# ADDENDUM NO. 05 – PORTAGE PUBLIC SCHOOLS – CENTRAL ELEMENTARY SCHOOL BP 4: CONSTRUCTION

# ADDENDUM NO. 5 (BP4)

PROJECT: Central Elementary School Bid Package 4: Construction

ARCHITECT'S PROJECT NO.: 21-237.10

1/2" = 1'-0"

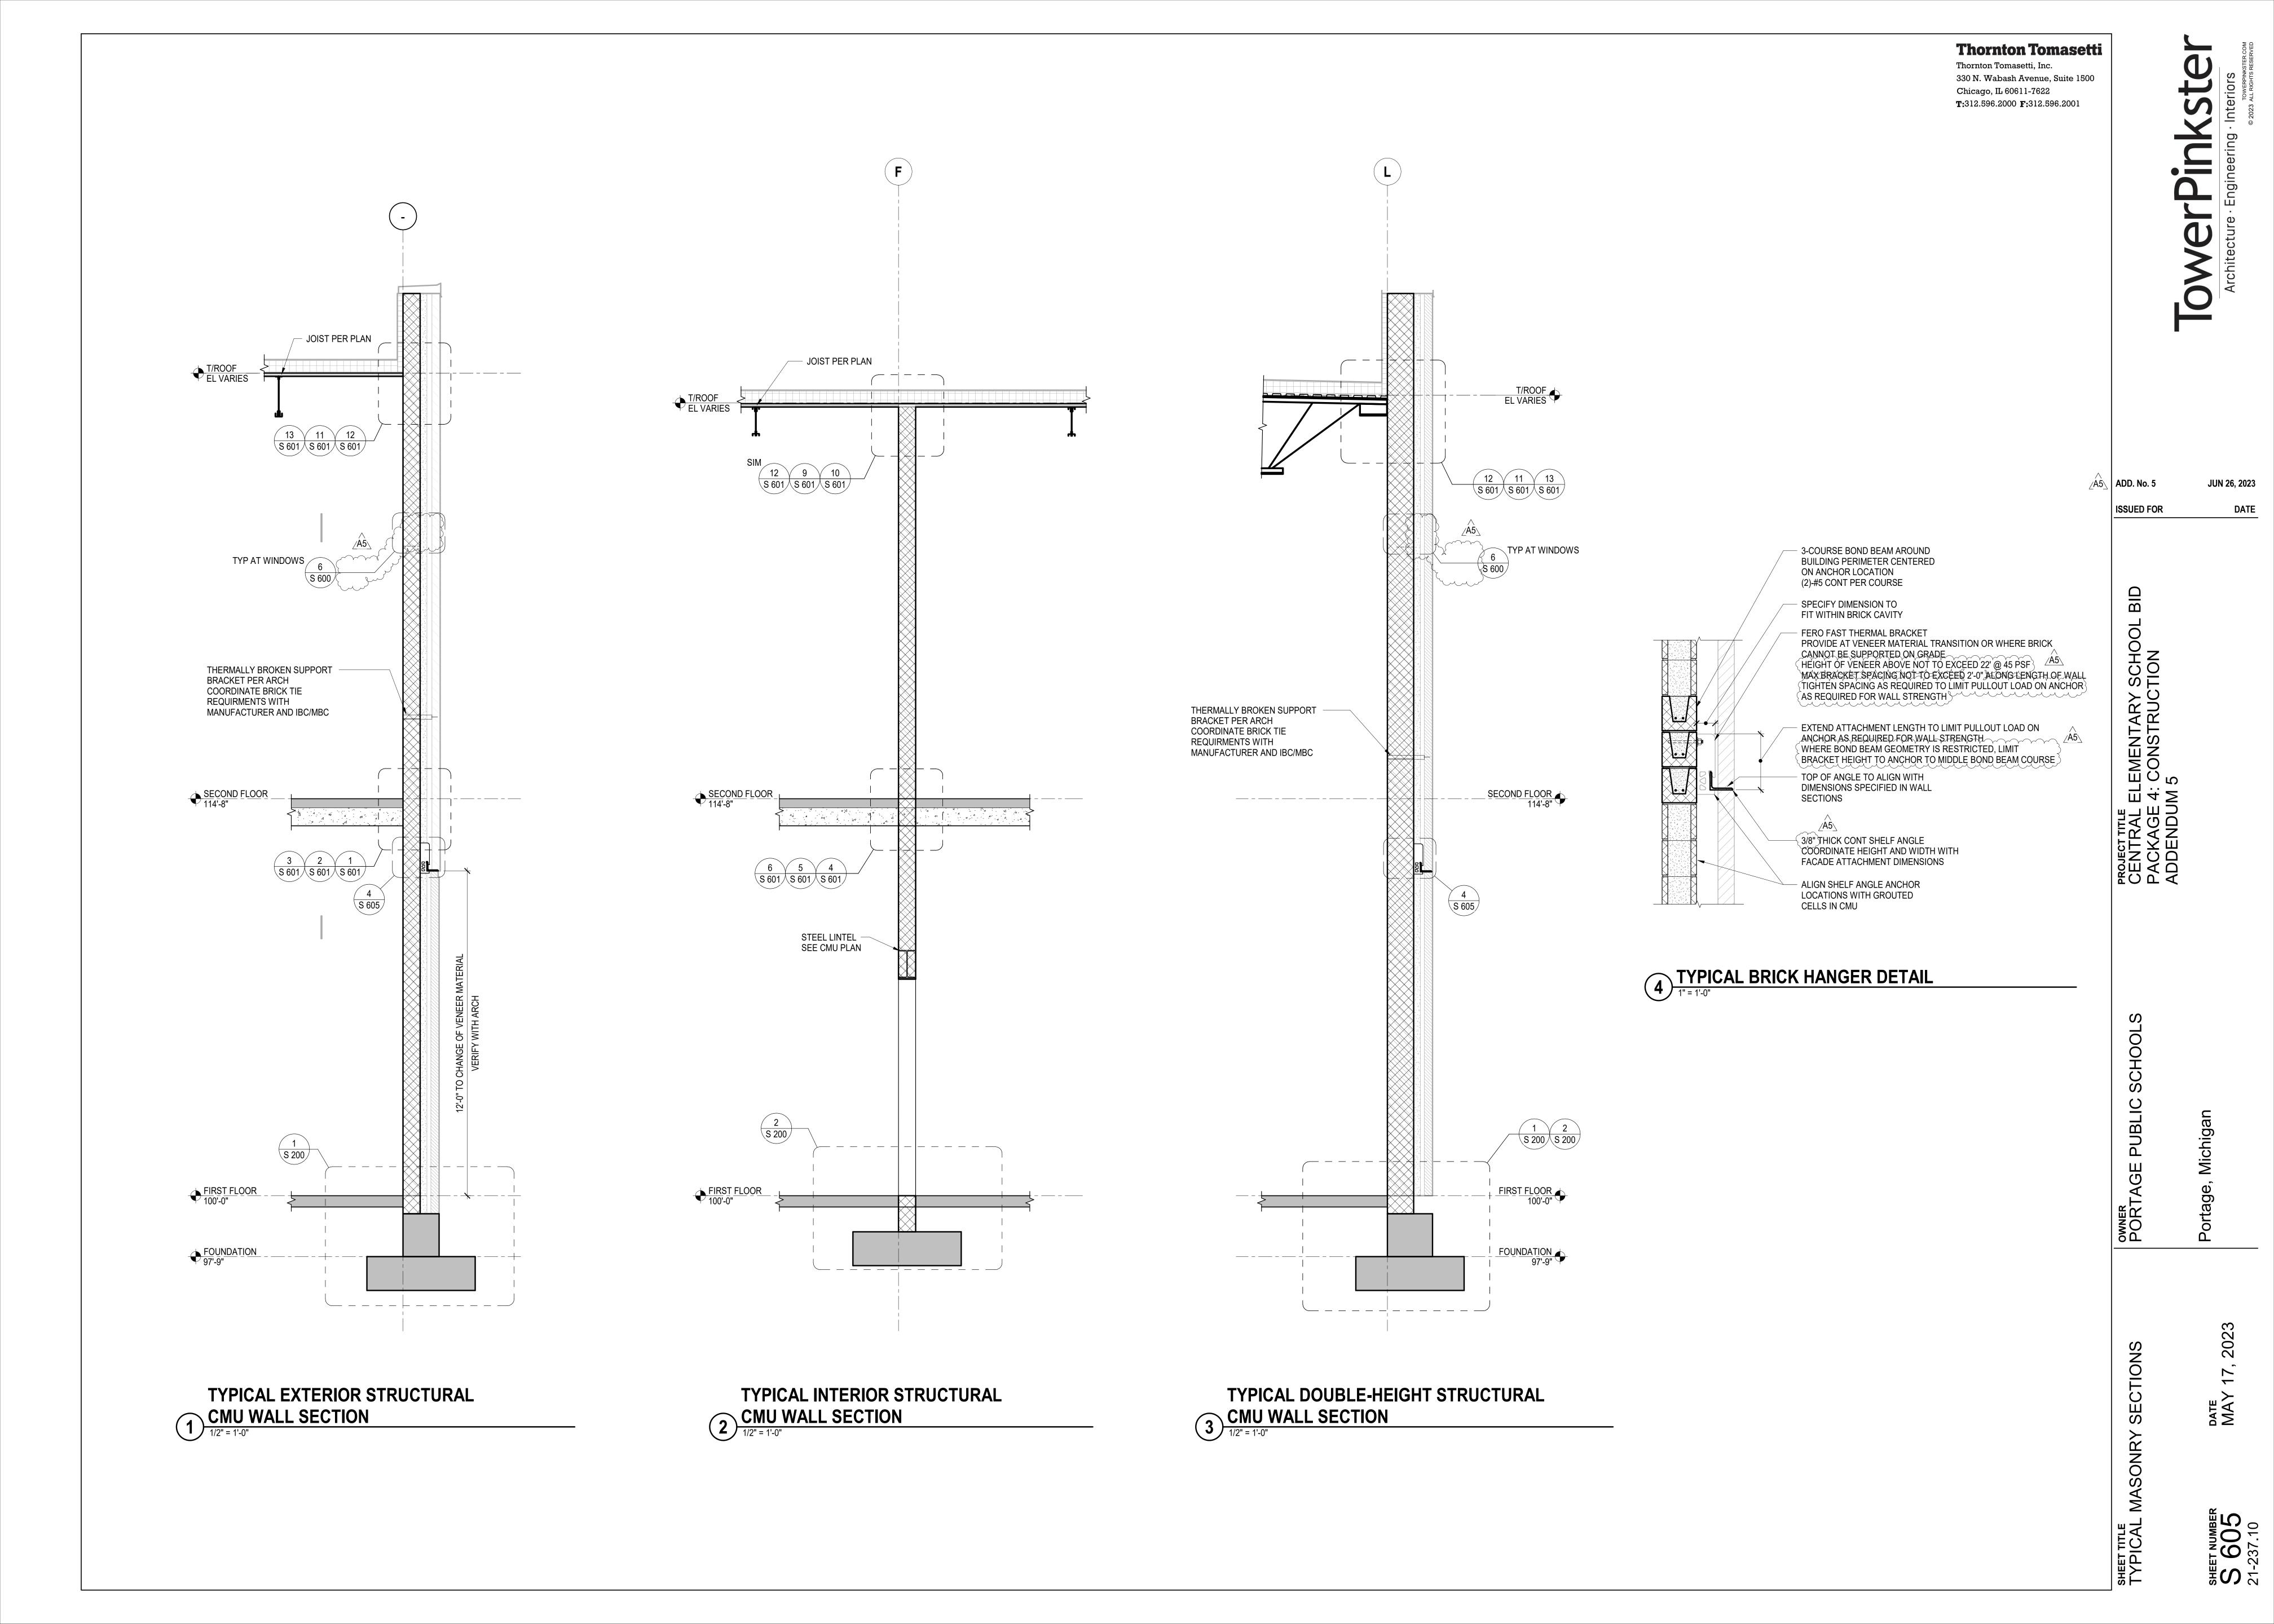
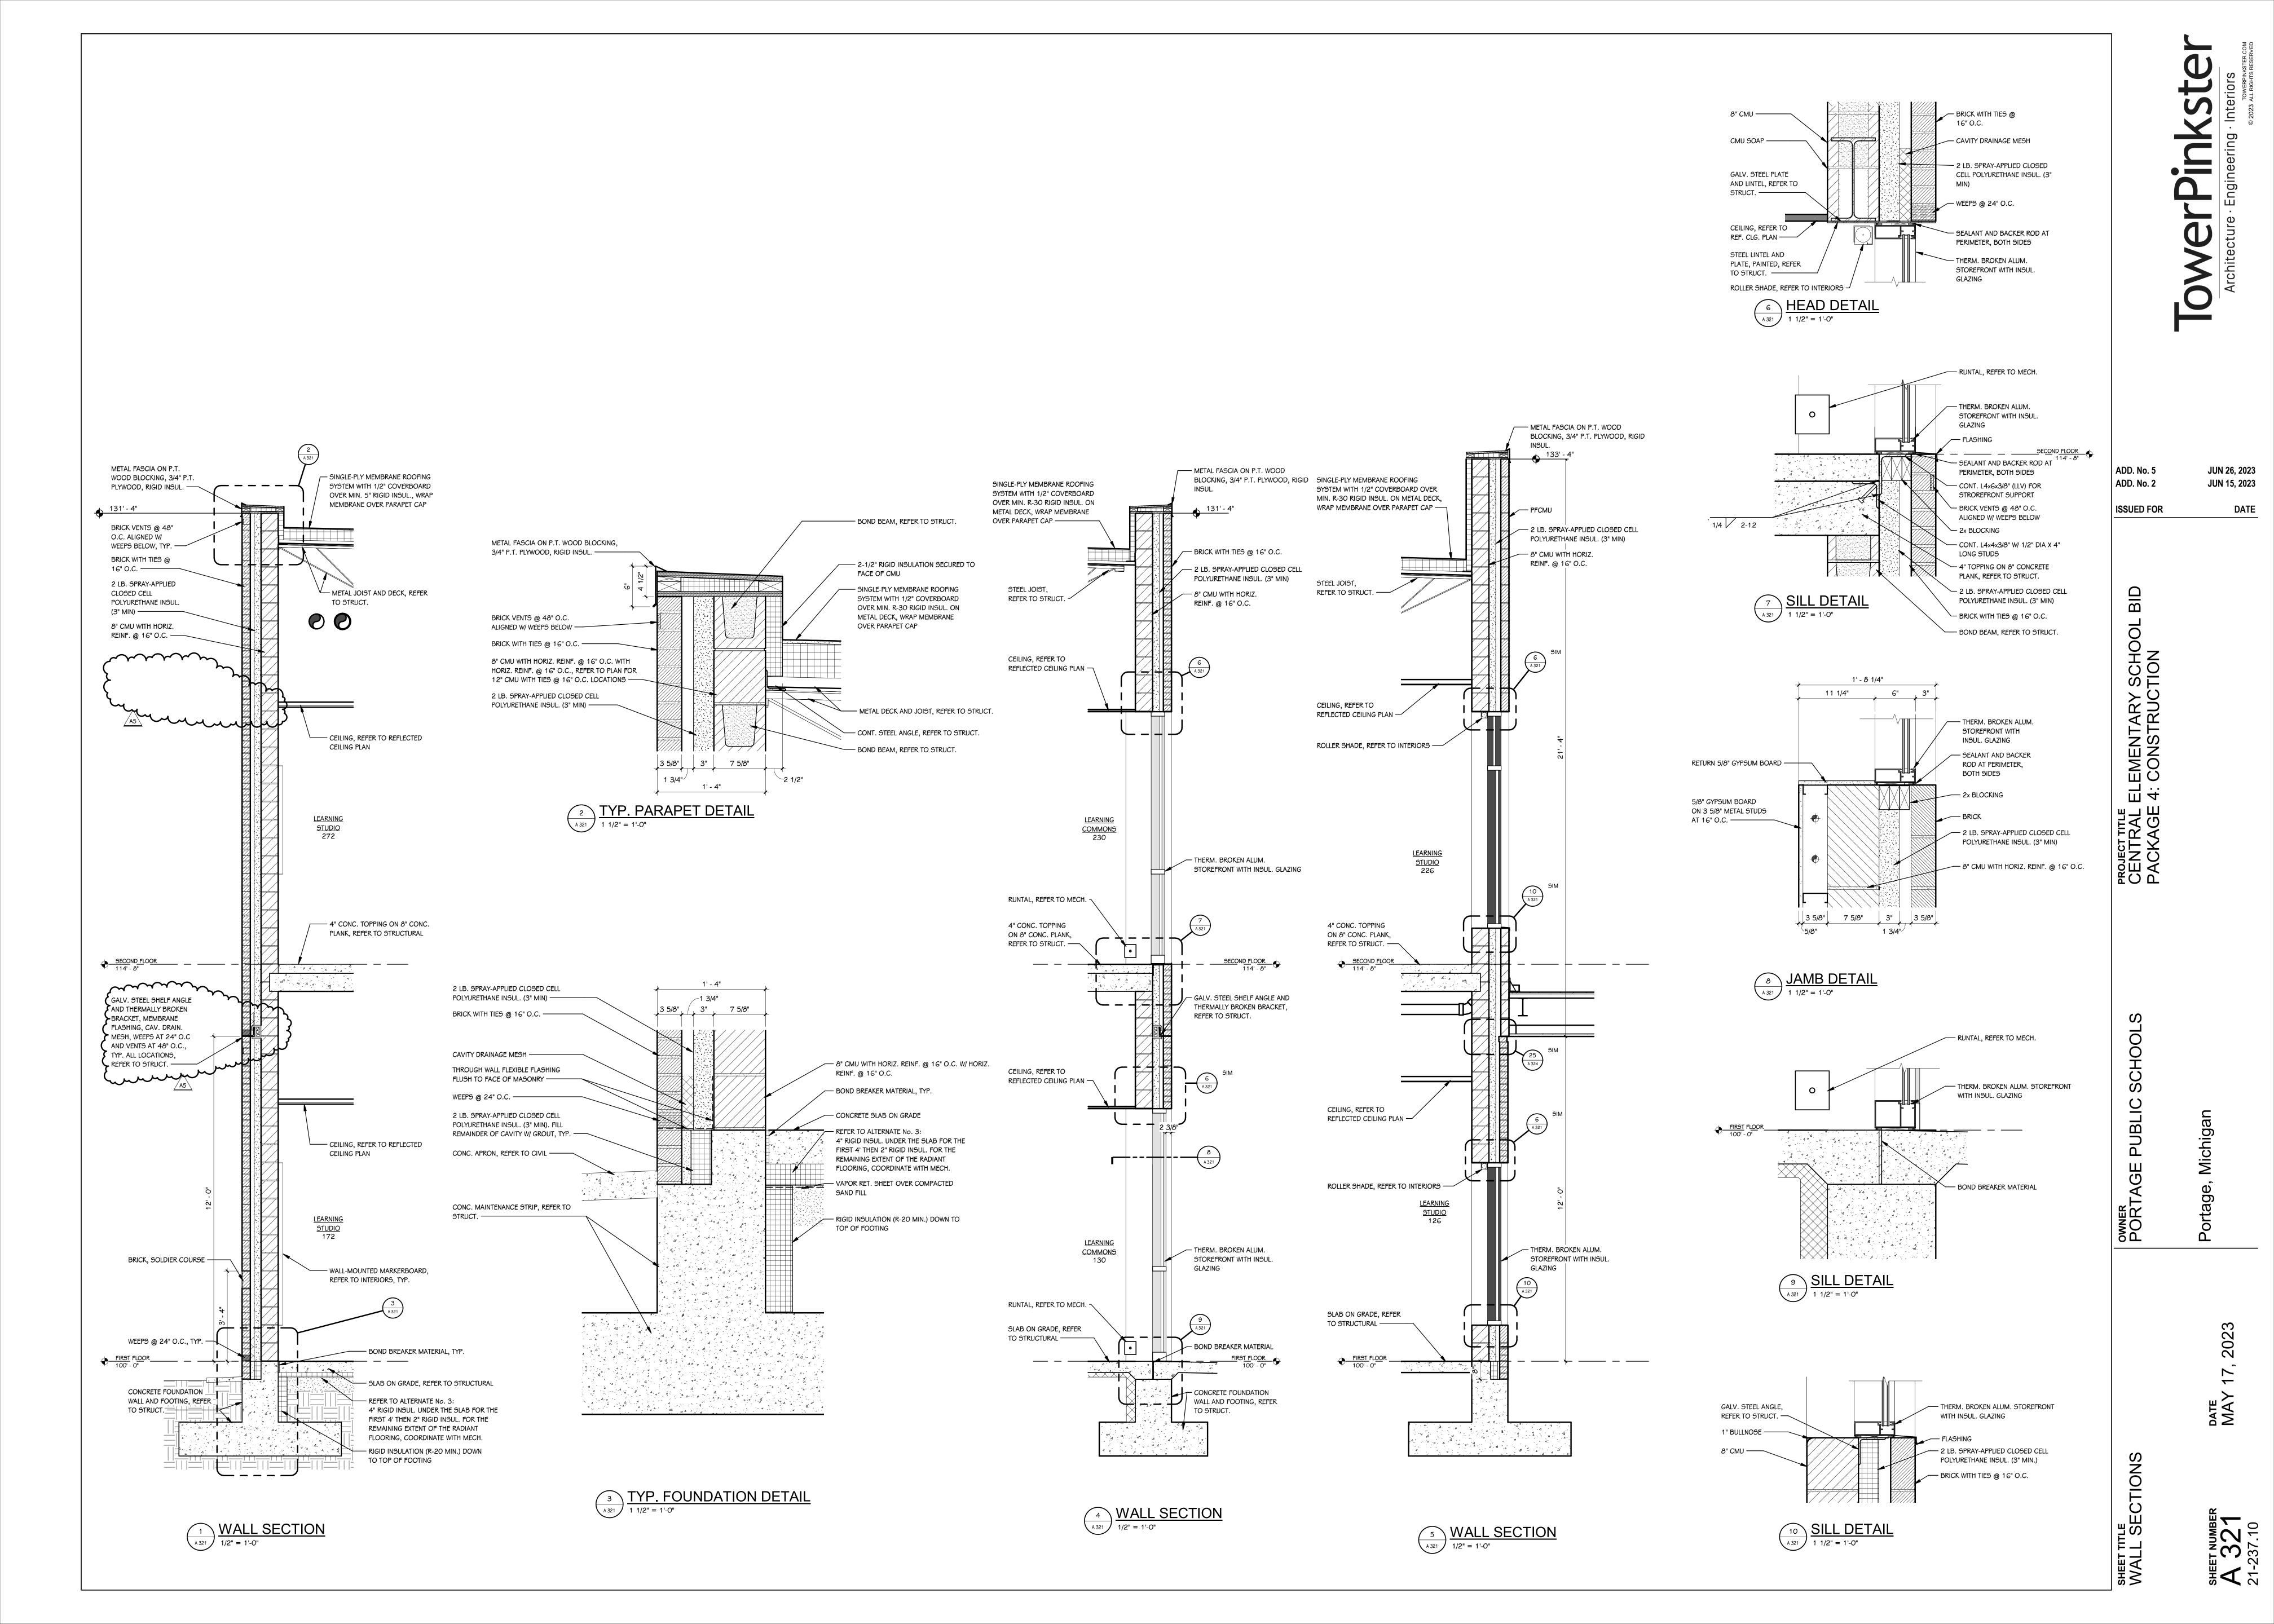
#### ADD-5 Item No. D-7 - Thermal Brackets at Veneer Bearing

Fero Fast thermal bracket detail updated. Thickness of continuous shelf angle is revised.

Revised wall sections to remove shelf angle and bracket in alignment with 2<sup>nd</sup> floor openings. Revised shelf angle and bracket note, added typical note to 1/A321, provide membrane flashing, cavity drainage mesh, weeps and vents at shelf angle [12'-0"h locations].
